# UNITED STATES PATENT AND TRADEMARK OFFICE

APPLICATION NO.	FILING DATE	FIRST NAMED INVENTOR	ATTORNEY DOCKET NO.	CONFIRMATION NO.
10/618,133	07/11/2003	Lixiong Li	ARA-US-PI	4427
44702	7590	02/22/2006	EXAMINER	
OSTRAGER CHONG FLAHERTY & BROITMAN PC 250 PARK AVENUE, SUITE 825 NEW YORK, NY 10177			SAVAGE, MATTHEW O	
			ART UNIT	PAPER NUMBER
			1724	
DATE MAILED: 02/22/2006

# Office Action Summary

FIG. 3

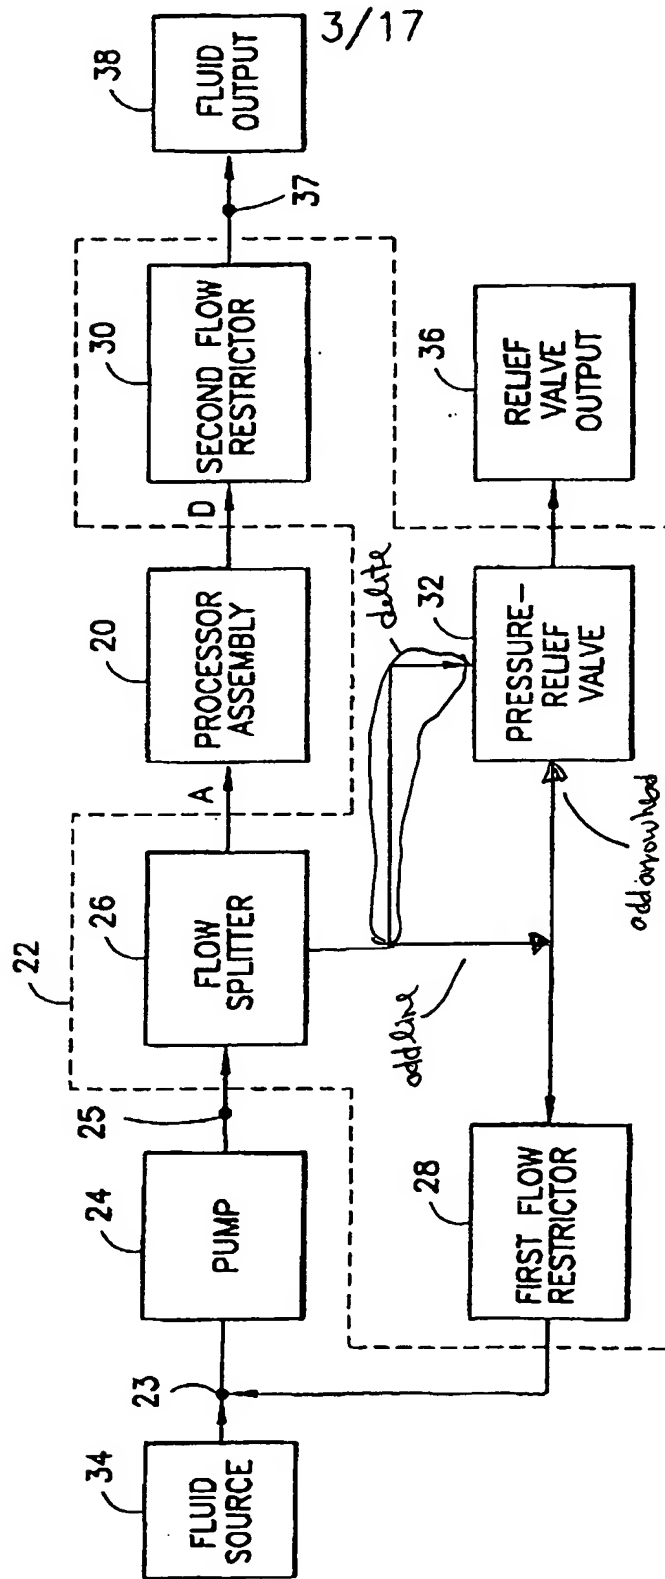
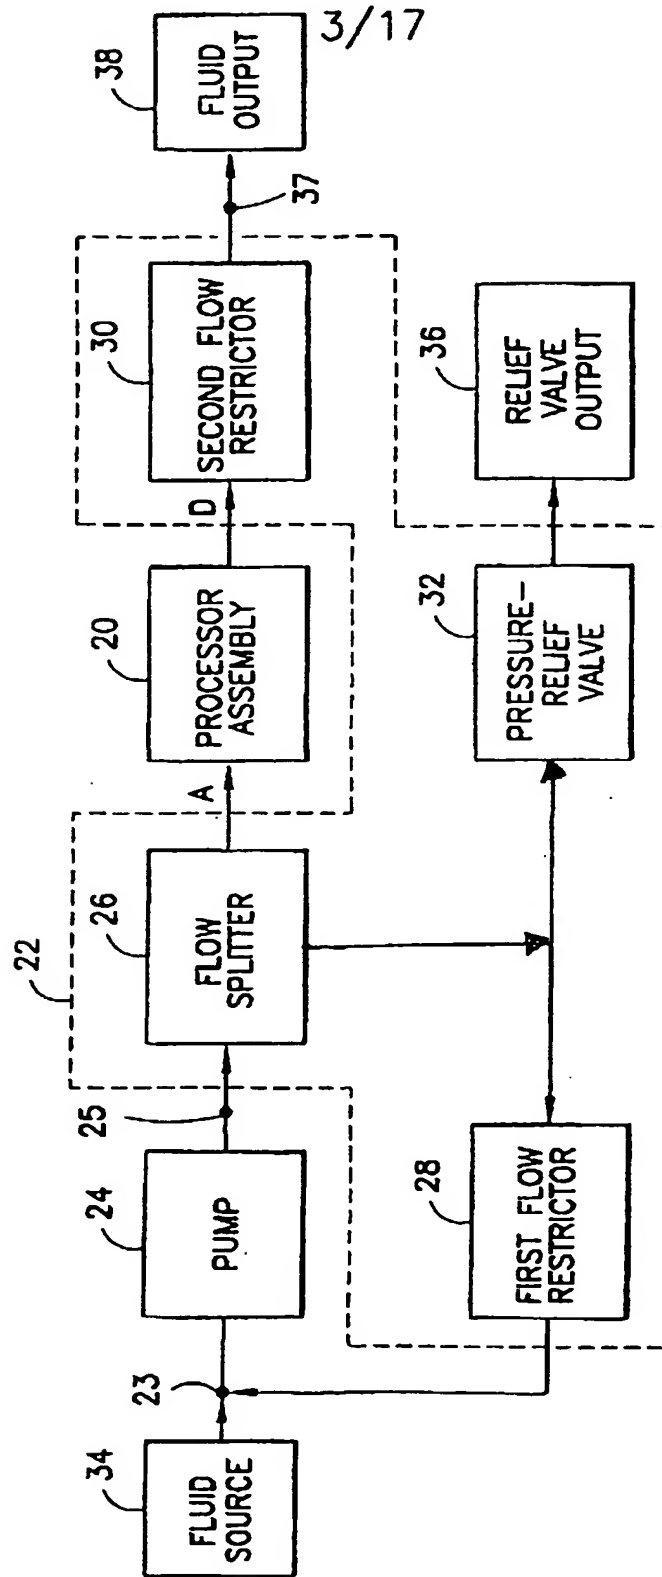
The amendment filed On 12-7-05 is objected to under 35 U.S.C. 132(a) because it introduces new matter into the disclosure. 35 U.S.C. 132(a) states that no amendment shall introduce new matter into the disclosure of the invention. The added material which is not supported by the original disclosure is as follows: the original specification fails to have basis for a pressure relief valve having a single inlet and a single outlet as shown in proposed amended FIG. 3.

The proposed amendment to FIG. 3 concerning the pressure relief valve filed on 12-7-05 has not been approved by the examiner for the reasons set forth above.

The proposed amendment to FIG. 3 filed on 12-7-05 out-lining the process control system 22 has been approved by the examiner.

Do not enter.  
ms

Okay to enter.  
148

Applicant is required to cancel the new matter in the reply to this Office Action.

FIG. 10A

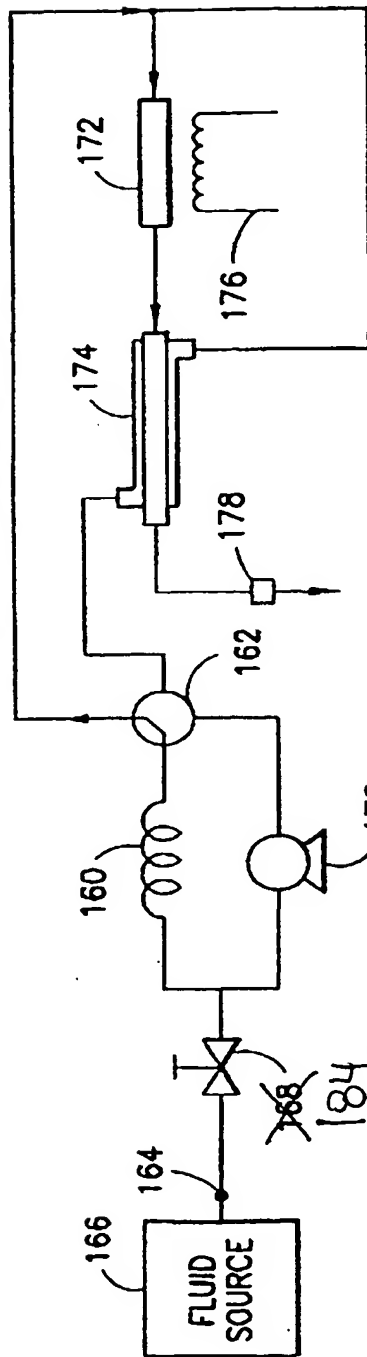
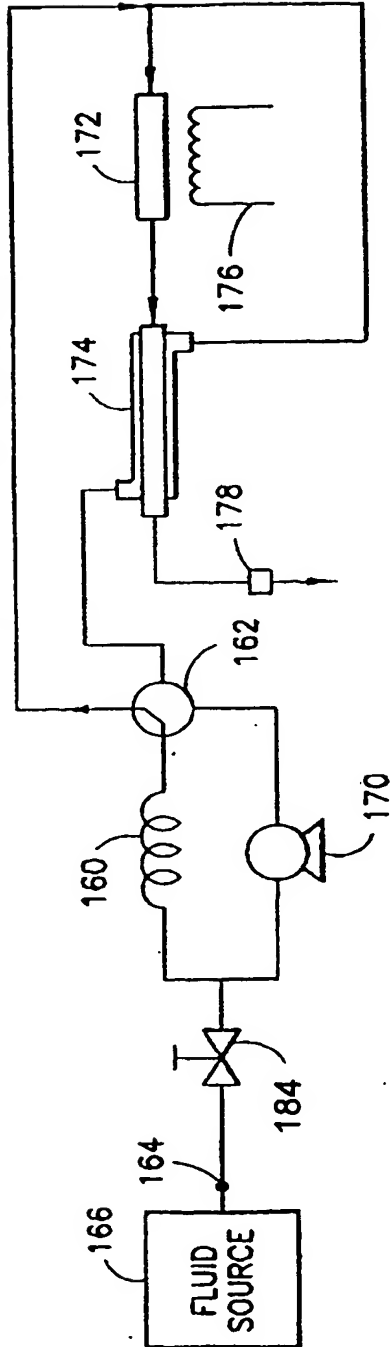
The proposed amendments to FIGS. 10A, 10B, 11A filed on 12-7-05 have been approved by the examiner.

Re-number  
168 to 184

FIG. 10B

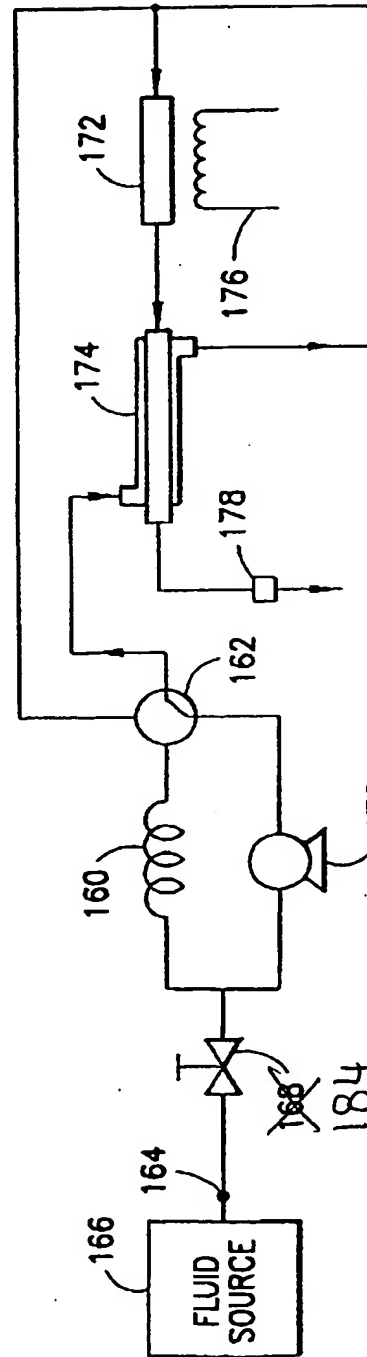
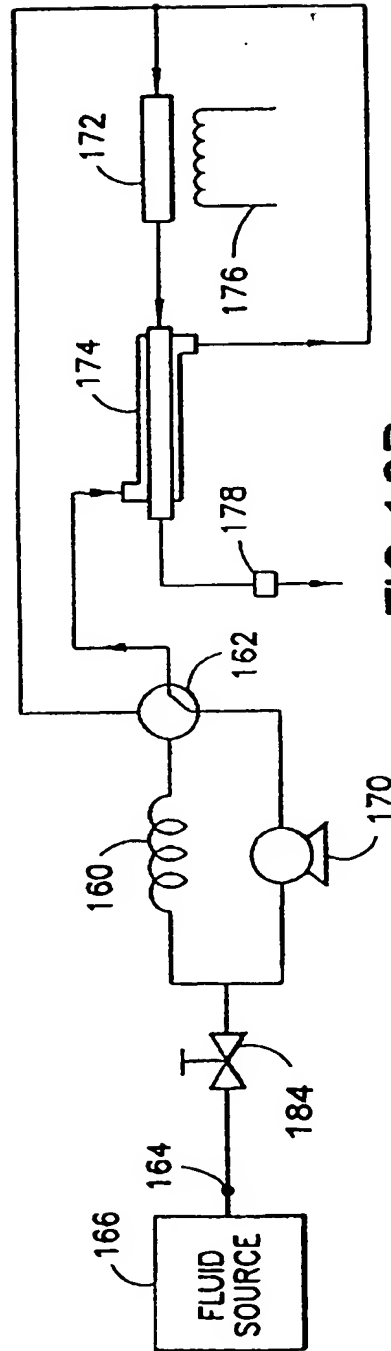
Re-number  
168 to 184

OK to enter.  
WJG

FIG.11A

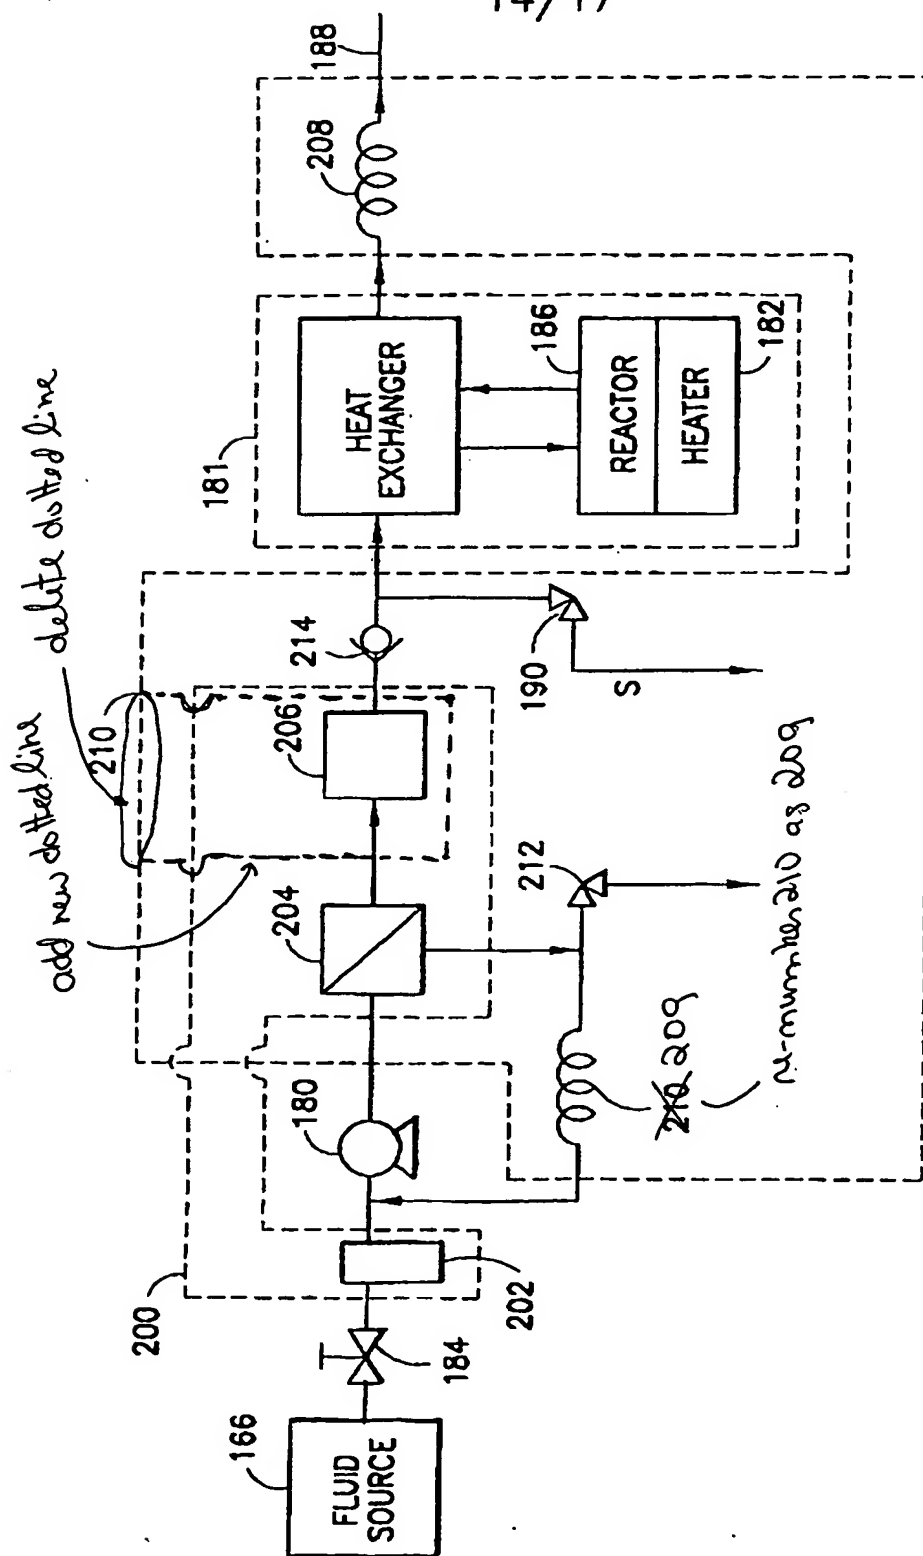
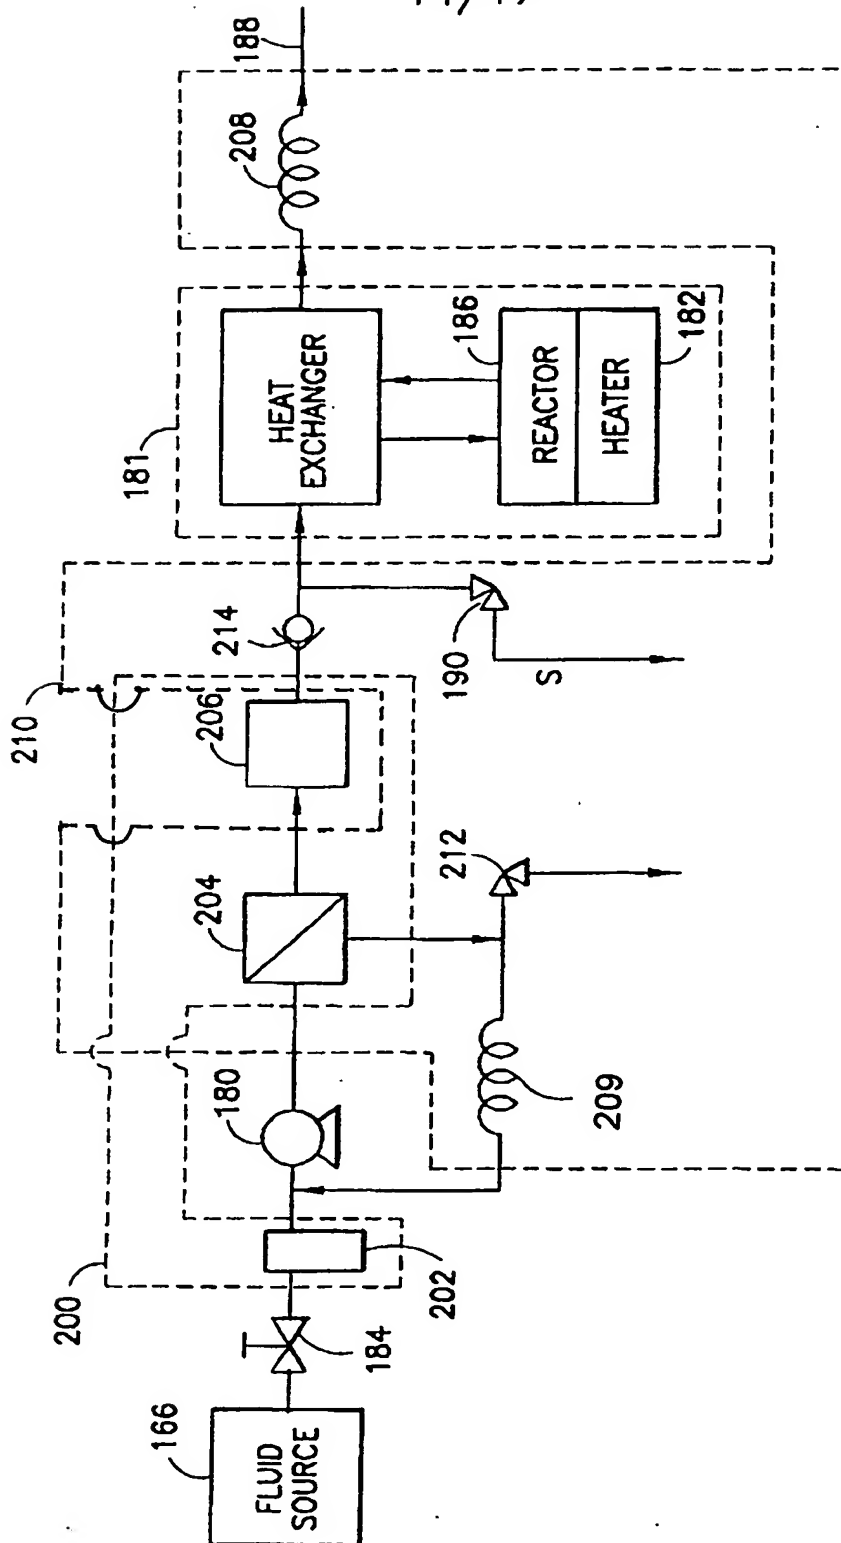
OKay to enter. ms

FIG. 11A Okay to install. 14g
